From: Brian Wirt <bwirt@mukilteowa.gov>
Sent: Thursday, February 2, 2023 8:27 AM
To: david.d.tyler@comcast.net
Cc: Andrew Galuska
Subject: RE: Harbor Grove

David,
Great question! The slope requirements in MMC 15.16.050 refer to the average slope of the entire property. The applicant has submitted a tree retention plan (TR-01). I have clipped the summary and attached.

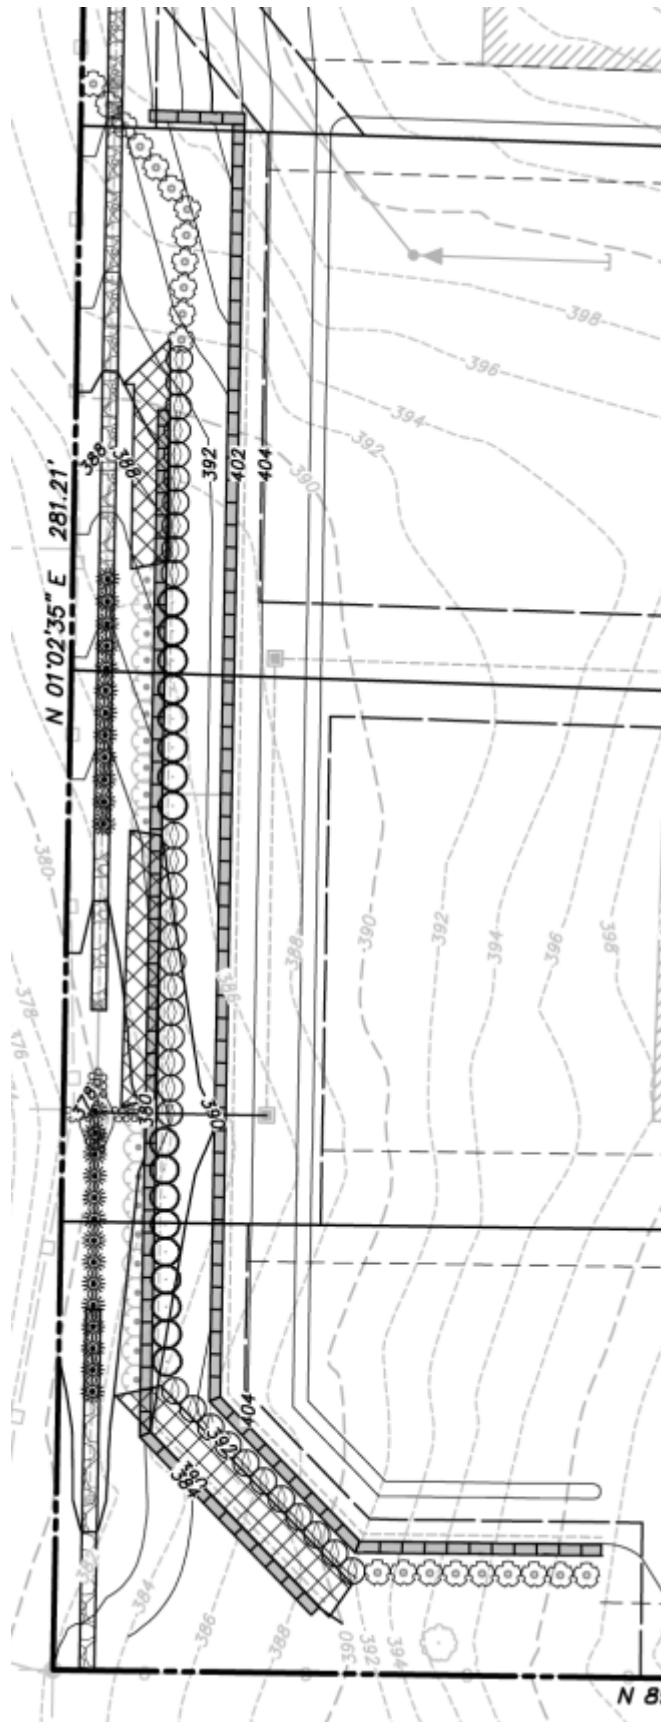
Thanks for your earlier reply. It seems that any wall or fence within the rear setback should be treated the same since the purpose of a setback requirement is to allow natural light and air on adjacent properties. This is particularly the case in a large lot single-family context--not so much in tighter urban areas. I would appreciate some additional perspective on the city's thinking--particularly since your application of the code would prohibit me from putting a 7-foot fence or wall along my property line, while allowing the applicant to place 20 feet of retaining wall along the same property line. And since the walls are hundreds of feet in length, this is not much different from putting a very large building within the setback, which would be impossible in a SF zone. This doesn't make sense--and it creates impacts.

MMC 17.20.080 refers to freestanding walls, which we do regulate like fences. However, the applicant is proposing retaining walls which are not regulated in the same manner. The project proponent is proposing landscaping to help reduce the visual impacts on the neighboring properties.
